HOMOLOGATION AND TECHNICAL SPECIFICATION UPDATE BULLETIN

HOMOLOGATION	Rotax 125 Micro Max	HOMOLOGATION NO.	110H
BULLETIN NO.	Rotax 14 MicroMax	BULLETIN DATE	9 December 2016
SUBJECT	Support Plate System for Micro Max Ignition Coil

Support Plate System for Rotax 125 Micro MAX

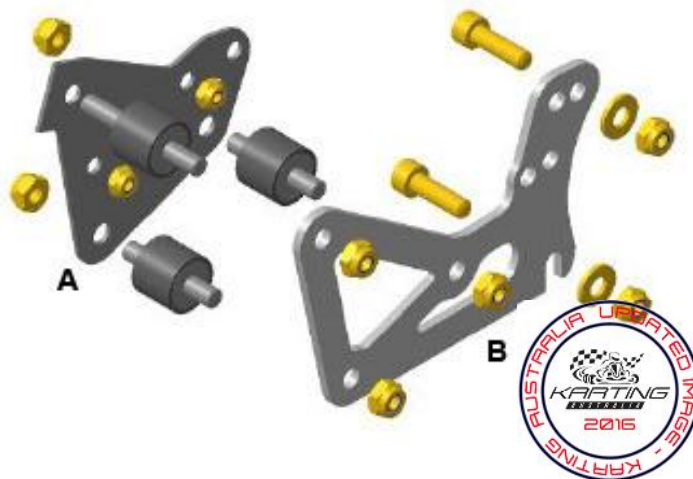
The new support plate system for mounting the ignition coil and magnet valve is a more compact system with less electrical connections at the backside of the engine, and the ECU now located in the battery housing. This system creates less risk of interference from any chassis components.

(A) Mounting Plate (Part No. 651 925)

(B) Retaining Plate (Part No. 651 935)
